Request for Approval of Alternative Waste Management Practices

Well Operator Cameron Energy Company		DEP ID 300544	Well Permit or Registration Number 123-49226	
Address 507 Cherry Grove Road			Well Farm Name Davis Lot 7	
City Clarendon	State PA	Zip Code 16313	Well # 7-60	Serial #
Phone 814-968-3337	Fax 814-968-3330	County Warren	Municipality Sheffield Township

DEP USE ONLY			
<input checked="" type="checkbox"/> Approved <input type="checkbox"/> Denied DEP Representative: Brian Ayers	Conditions: <input checked="" type="checkbox"/> YES, see below or attached. <input type="checkbox"/> NO	Date 02.17.26	
Conditions: Please abide by the attached special conditions.

Proposed
Drill / Frac
Pit Area

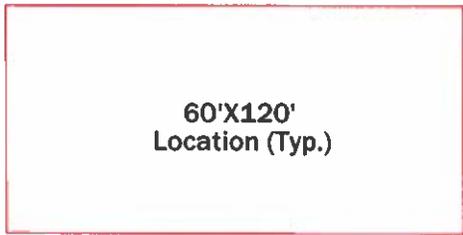
1. Notify their local Oil and Gas Inspector three days prior to dusting.
2. Drill cuttings shall remain on the well site they are generated and shall not be dispersed off-site via air, surface water, or groundwater.
3. All isolation distances identified in 25 Pa. Code § §78.60 – 78.63 are applicable.
4. Drill cuttings may be disposed of in a pit, without contact with season high ground water.
5. Upon well completion, the pit shall be backfilled and graded to promote runoff. The stability of the backfilled pit shall be compatible with surrounding area and the pit area shall be revegetated to stabilize surface soil.
6. Land application may only occur on the cleared well pad area and the drill cuttings shall be spread and incorporated to a depth of at least 6 inches and revegetated to stabilize surface soil.
7. No land application shall occur if the ground is frozen or saturated.
